Port Credit West Village

Street Right of Ways: Response to City Comments

2018.11.02

For City of Mississauga, by
the West Village Partners

Overall

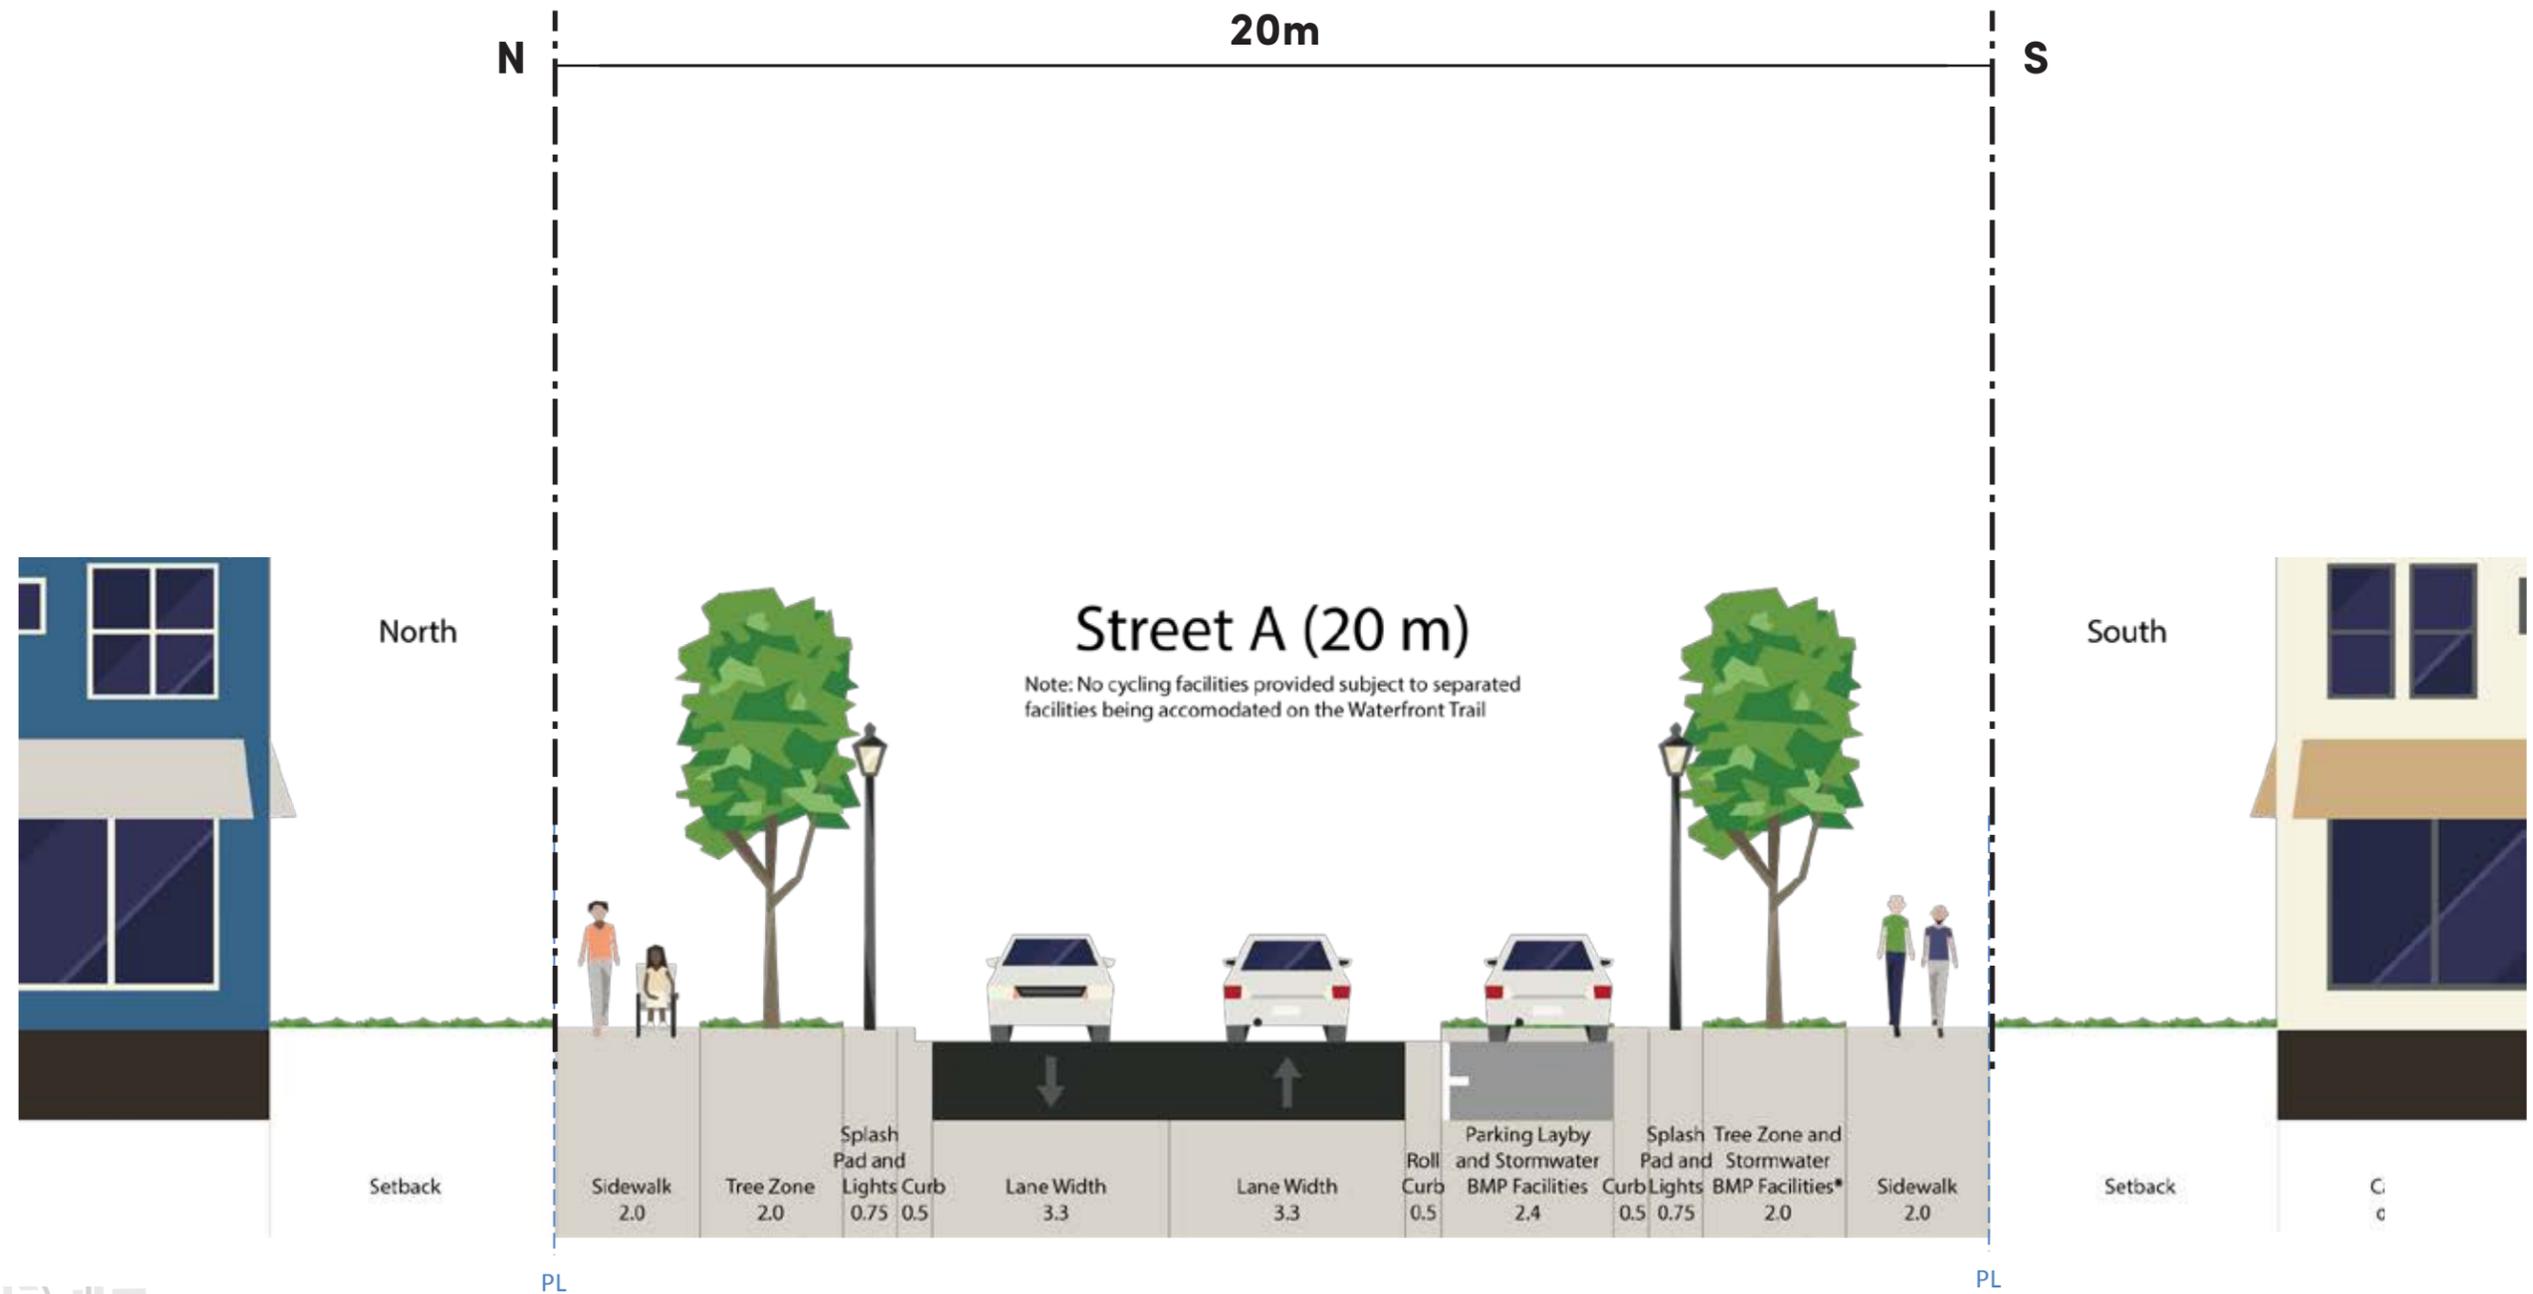
Revised Approach: Trees

Trees will be accommodated on both sides of each street (except street 'B', as already acknowledged by the City) in a minimum 2m wide zone or larger. In order to get bigger and longer lived trees, we have strategically located them next to the garden setbacks, where they can leverage the wide, typically less compacted soil reserves in the adjacent private gardens.

Revised Approach: Biking, Walking and Curbside

In line with City comments, cycling has been removed from Street 'C' and 'E'. We'll continue to accommodate it in the Mews - and in the now recently added private Street 'G' - for connectivity east-west between the Benson Trail and Mississauga Road.

Per the City's feedback sidewalks are to be 2m wide across the site, except where we need to accommodate utilities below. In such an instance, we have widened to 2.2m to meet the utility companies negotiated access demands.

The design team have revised plans and sections with a view to optimizing curbside activities in tandem with green infrastructure, by placing the LIDs in curb bulb-outs. Since we are required to keep parking away from intersections regardless, this is a natural synergy that strikes the right balance, keeping vital curbside space while ensuring it doesn't visually overwhelm the West Village Streets.

Revised Approach: Low Impact Development

Based on the City's feedback we have consolidated the LID's into larger, more substantial bump out features which will be easier to maintain, while preserving considerable curbside space for parking and drop off and maintaining sightlines at intersections.
